# Access Compliance Report

## Public Rights-of-Way

### (Curb Ramps)

Intersection ID: 6421	Main Street: S_SHOPPING_CENTER_DR	Cross Street: UNIVERSITY_CITY_BV	Location: SE
ADA ID: DD98B0677286	Ramp Type: Perp	Initial Pass/Fail: Fail	Overall Compliance: No
Codes/Mitigation Info/Possible Solution			Severity Score: 25
			Field Measurements/Component Compliance

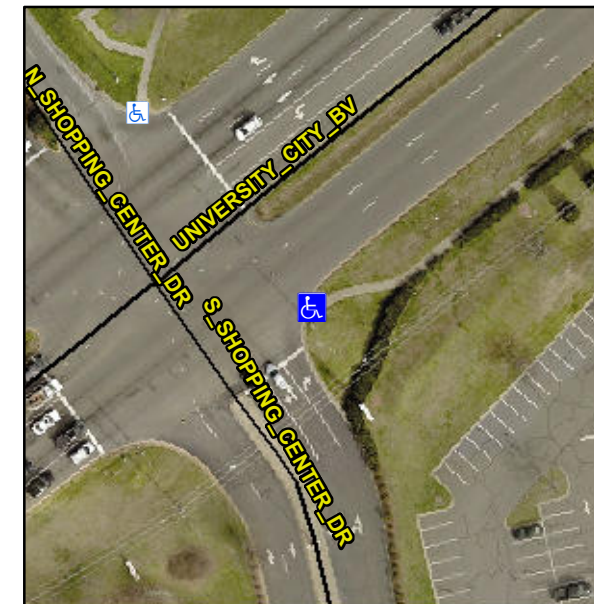
**Not Found, R304.2.2**

Compliance	Description	Data	Compliance	Description	Data
N/A	Ramp Length (in)	32.5	No	Ramp Slope (%)	16.2
Yes	Ramp Width (in)	48.0	Yes	Ramp XSlope (%)	1.5
N/A	Flare Type LT	N/A	N/A	Flare Type RT	N/A
N/A	Flare Slope LT (%)	N/A	N/A	Flare Slope RT (%)	N/A
N/A	Flare Traversable LT?	N/A	N/A	Flare Traversable RT?	N/A
N/A	Landing Length (in)	N/A	N/A	DWS Provided?	N/A
N/A	Landing Width (in)	N/A	N/A	DWS Contrast?	N/A
N/A	Landing Slope (%)	N/A	N/A	DWS Length (in)	N/A
N/A	Landing X Slope (%)	N/A	N/A	DWS Full Width?	N/A
N/A	Landing Curb? (Y/N)	N/A	N/A	DWS Offset (in)	N/A
N/A	Shared Landing?	N/A			
N/A	Gutter Ponding?	N/A	N/A	Gutter Slope (%)	N/A
N/A	Gutter Lip Ht (in)	N/A	N/A	Gutter X Slope (%)	N/A
N/A	Painted X Walk1?	No	N/A	Painted X Walk2?	N/A
	X Walk 1 Direction	To N		X Walk 2 Direction	N/A
N/A	X Walk 1 Width (in)	N/A	N/A	X Walk 2 Width (in)	N/A
	X Walk 1 Slope (%)	5.5		X Walk 2 Slope (%)	N/A
	X Walk 1 X Slope (%)	4.0		X Walk 2 X Slope (%)	N/A

**Remove & Replace Entire Ramp.**
